**Sub:-** Diversion of 0.9918 Ha. of forest land in favour of Director of Technical Education, Vocational & Industrial Training H.P. Sundernagar, Distt. Mandi, HP for the construction of Govt. Polytechnic Jandour in Tehsil Jaswan Distt. Kangra, within the jurisdiction of Dehra Forest Division Kangra H.P. (Online No. FP/HP/Others/114095/2020).

This with reference to the Nodal Office letter No. Ft. 48-5212/2020 (FCA) Dated 25<sup>th</sup> Aug. 2022 on the subject cited above. In this context this is to inform you that the EDS raised by your department has been attended as below:

# Muck Management Plan

# Layout Plan of Govt. Polytechnic Jandaur in Jaswan Distt. Kangra H.P.

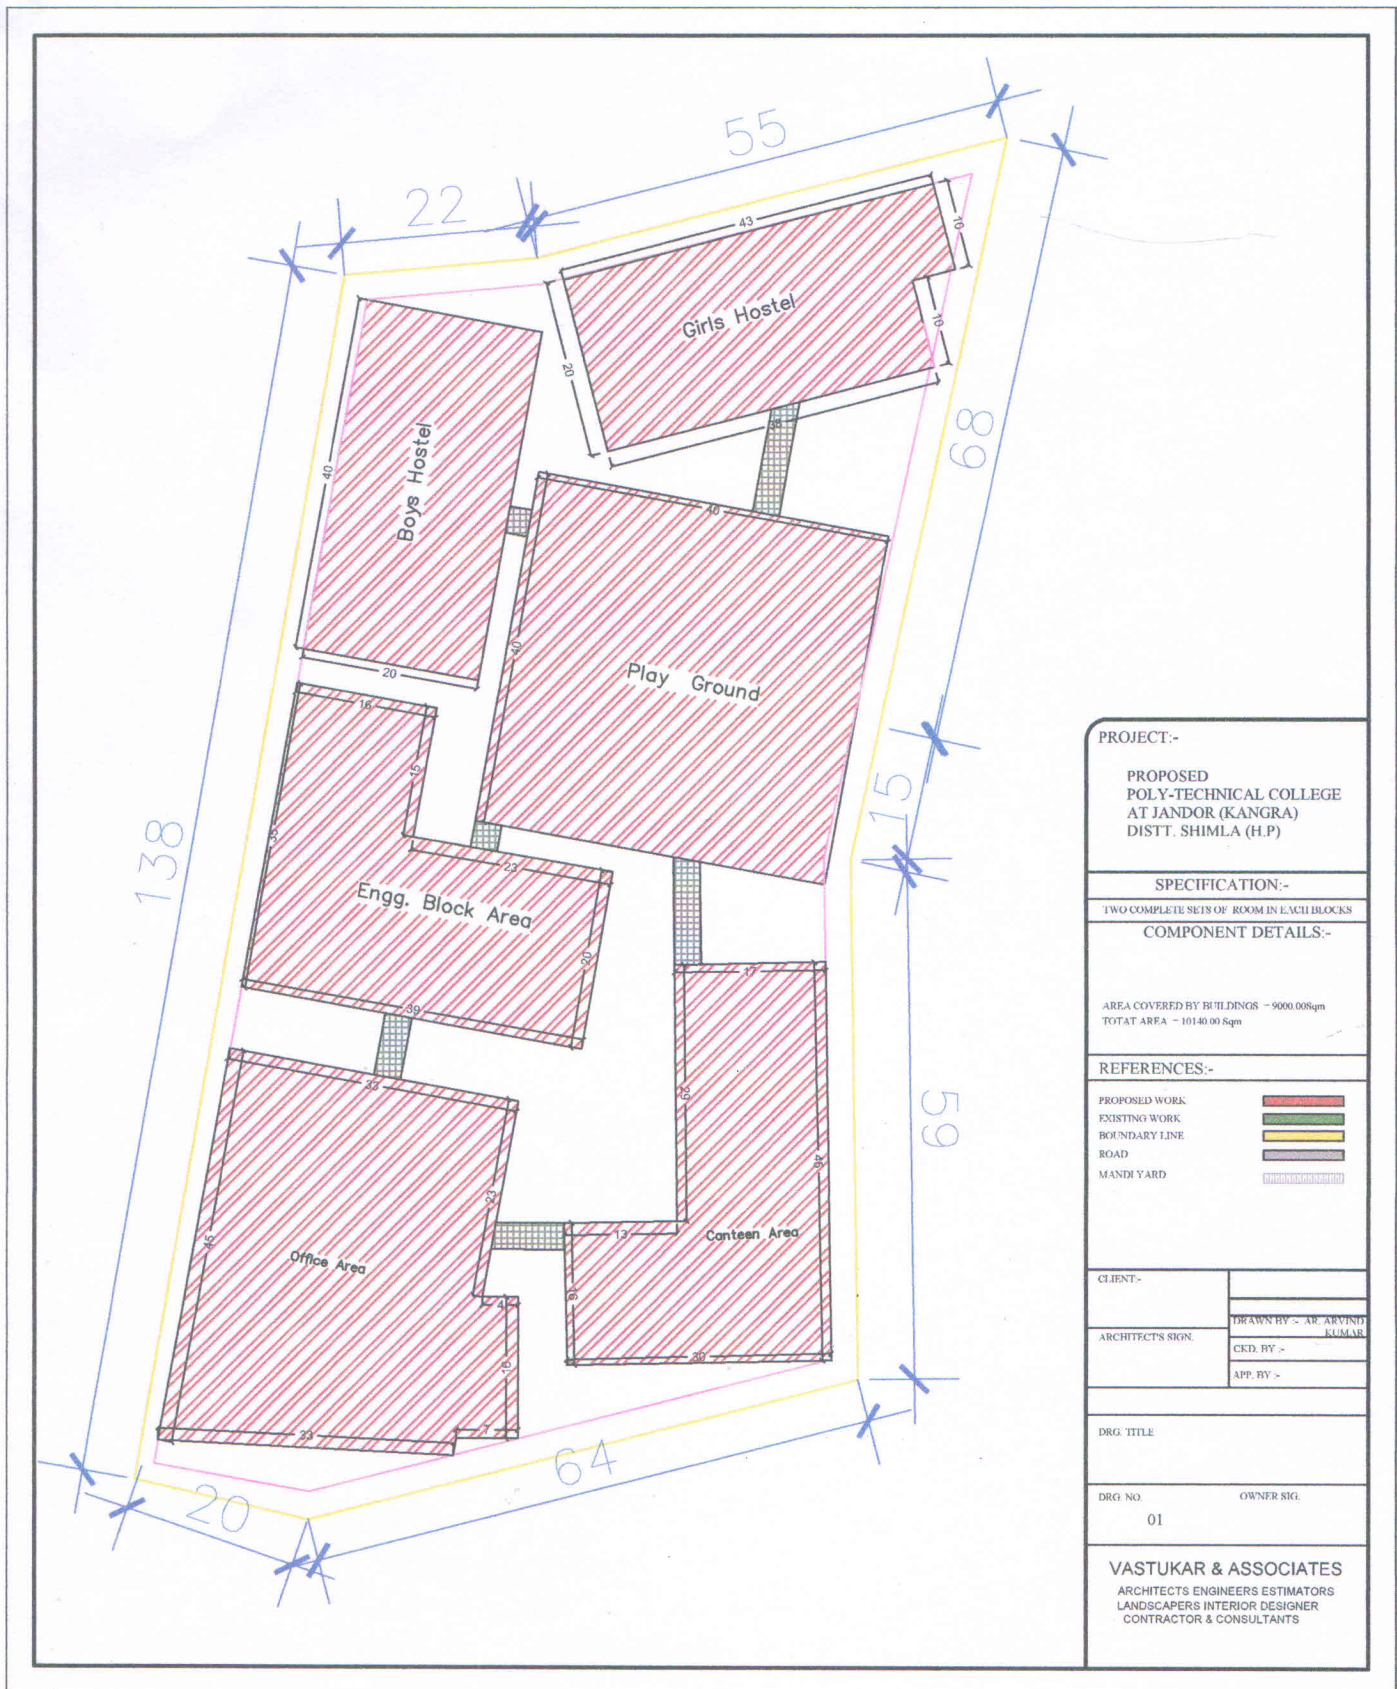
| 9.  | The muck management plan has not been found placed in the proposal folders. In case muck to be generated will be used in the construction area then the detail of muck to be generated and to be used is required to be given along with the undertaking regarding use of such muck is required to be given. | The muck management plan has been attached and uploaded on the portal |
